State Significant Development Application SSD-21208499
Glanmire Solar Farm
Site: 4823 Great Western Highway, Glanmire (Lot 141 in DP 1144786)
Submission on behalf of Fitzsummer Pty Ltd

BDAR Review for 4823 GWH Glanmire

Responses to Submissions Report: Glanmire Solar Farm, September, 2023. From Urbaine Design Group, October, 2023.

Figure 4-14 View east along the Great Western Highway, view alignment and photomontages

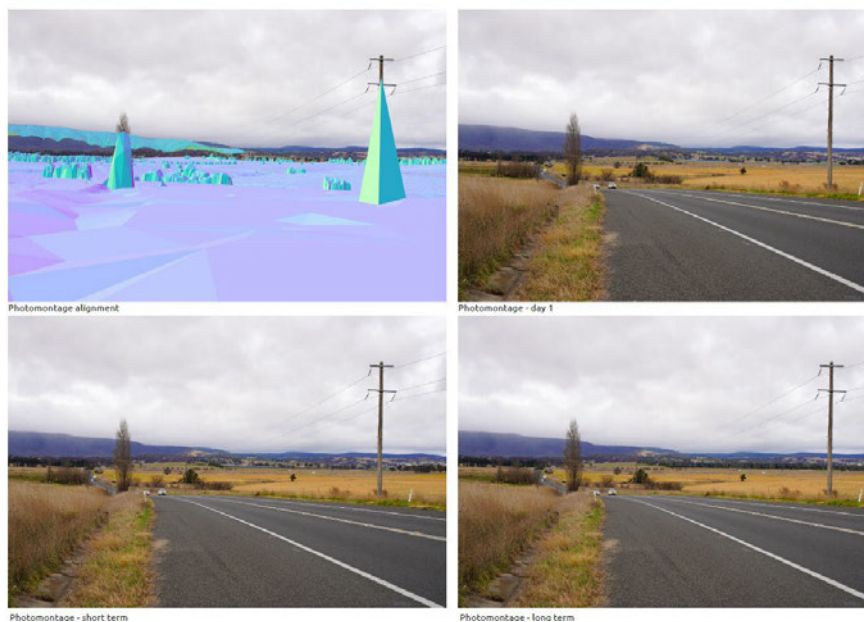
Importantly, LIDAR data does not verify a photomontaged view, but is one small part of the process of creating accurate photomontaged views, for the assessment of Visual Impact. As detailed within the Urbaine Report, the LIDAR data has not been accurately positioned over the base photography, in this instance, resulting in an inaccurate visual representation of the development. The alignment of LIDAR information over photography is not an automatic process and needs to be applied with great care and accuracy.

The misalignment of the existing landscape can be clearly seen in Figure 4.14, where the distant topography is misplaced by several hundred metres, in the far distance. The LIDAR mapping of existing trees is also significantly misaligned.

Views from the east, along the Great Western Highway, have been ignored and the setback to the site, in the northeastern corner, only serves to reduce the impact, but not to eliminate it, as suggested by the Applicant. This has been analysed within the Urbaine response document, December, 2012, where the built forms of the development have been shown in the correct location and height.
